MEMORANDUM

RE: 12103 Hayland Farm Way  
Clarksville, MD 21029  
*Potential Basement Bedroom*

**PERMIT SITE PLAN**  
LOT 68  
12103 HAYLAND FARM WAY  
**WALNUT CREEK**  
PHASE TWO  
ZONED: RC-DEO

# CLIFTON PARK II

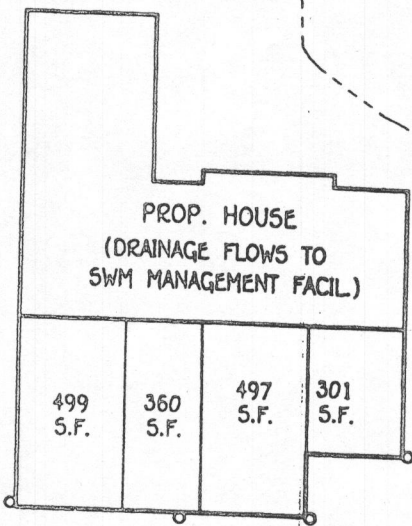
I have reviewed the building permit B16001935 for 12103 Hayland Farm Way and have a couple of comments. On the site plan there needs to be a sleeve illustrated on the portion of the sewer house connection underneath

the drive way. Are the sewer house connection elevations field run topography? Also are the bathrooms in the basement and on the first floor both full baths?

The permit processor for NV Homes forwarded me your comments on this Permit Site Plan (I have pasted them below). I have shown a detail on the Permit Plan for sleeving of the sewer house connection for the portion that runs under the driveway. I'm a bit confused about your question about the sewer house connection elevations. The elevations on the sewer house connection are proposed elevations based on the elevation of the grinder pump that is installed. The topo for this project is aerial topography.

PROVIDE 6" PVC SCHED. 40 SLEEVING FOR SHC

MODEL: CLIFTON PARK II  
DRAWING TITLE: BASEMENT PLAN  
OPTION: FULL BASEMENT

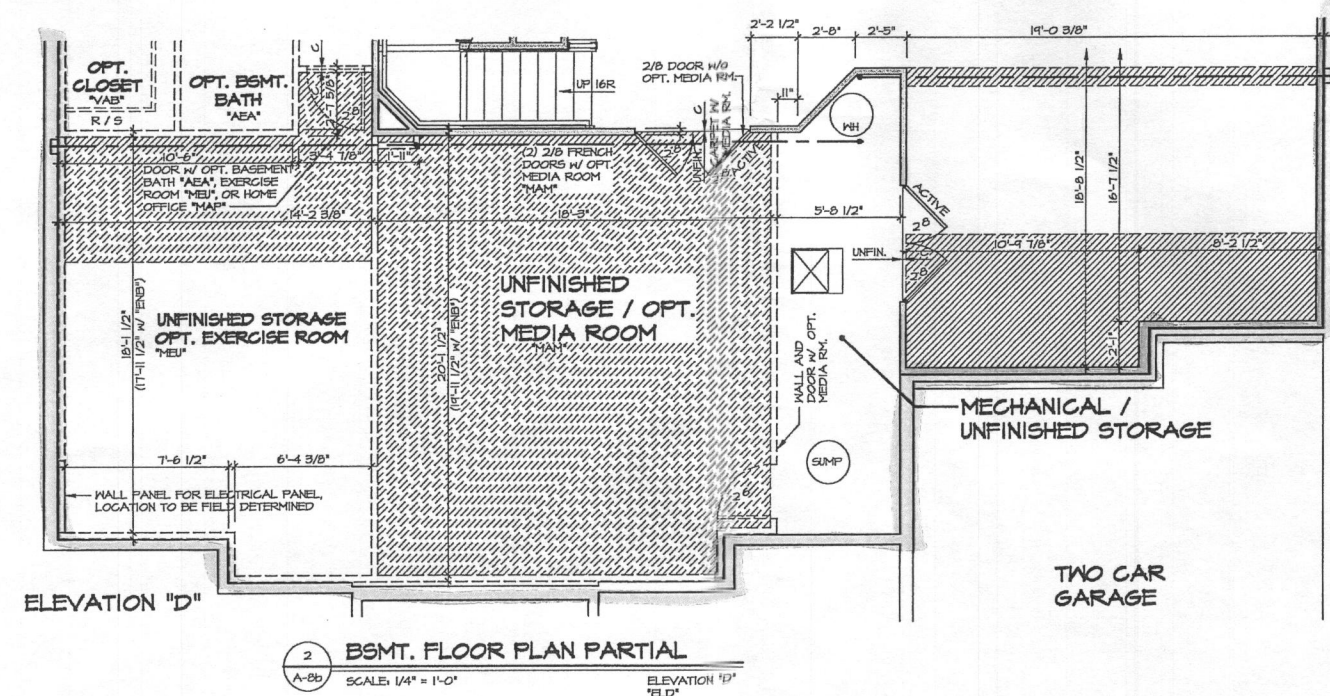
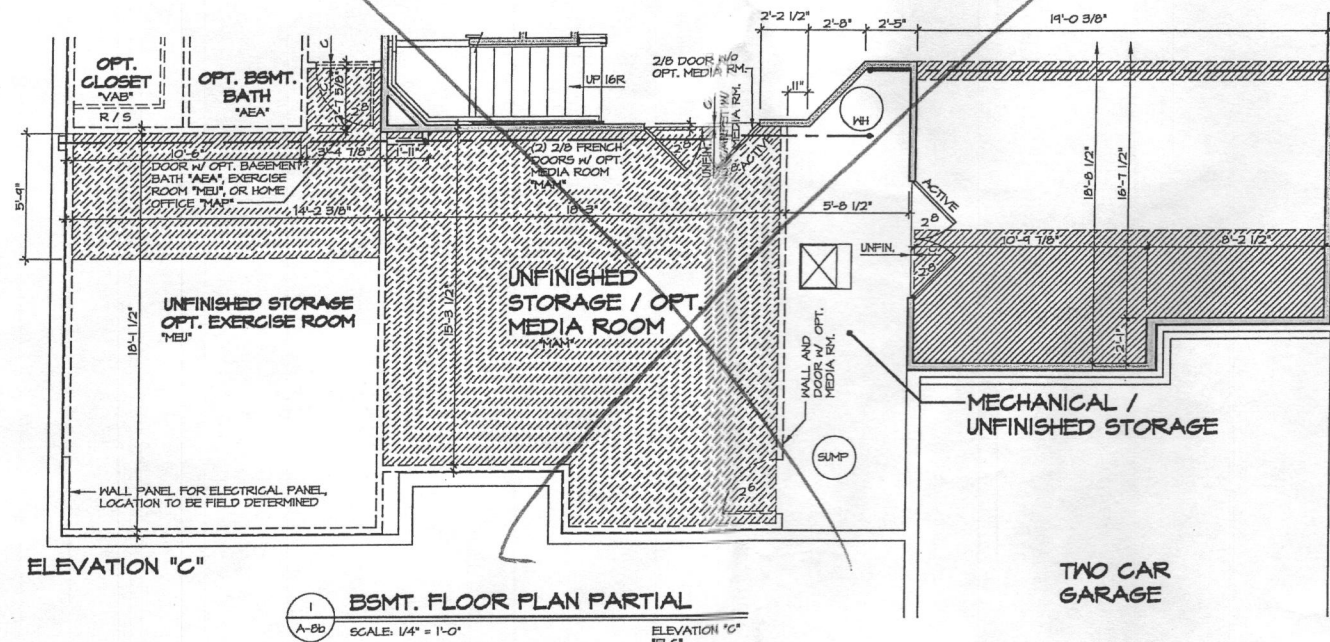
I have reviewed the floor plans in support of Building Permit B16001935 for a new home at **12103 Hayland Farm Way Clarksville, MD 21029** and noted that there is a full bathroom in the finished basement. Please note that this makes it very likely for one or more rooms to be considered bedrooms upon conversion of the unfinished rooms in the basement to finished living space. As this lot is connected to the shared sewage system with a **five** bedroom per lot limitation, any future building permit for converting the unfinished portion of the basement into finished living space may be denied by the Health Department if the total number of proposed bedrooms in the dwelling is above five.

plans you sent are missing the second floor and still mention the bedrooms in the basement and the first floor as possible options. The building summary on Accela also makes mention of 6 bedrooms. The shared septic system on this lot allows for five bedrooms to be built per single family dwelling. As for the sewer house connection I want to make sure the Grinder pit invert for this lot was field run topography and not based off an old plan. Let me know if you have any questions.

I just wanted to make sure you understand that NV is going to finish the basement except they will not build the Home Office (the Home Office was the concern you had as being interpreted as a possible bedroom, so they are deleting it. They will process a revised building permit thru DILP.

I received copies of the revised floor plan and they look approvable. I do need the building permit to be revised as well stating the basement will be unfinished. Once the I see building permit and floor plans have been submitted through DILP I can go ahead and approve them on Accela. Let me know if you have any questions.
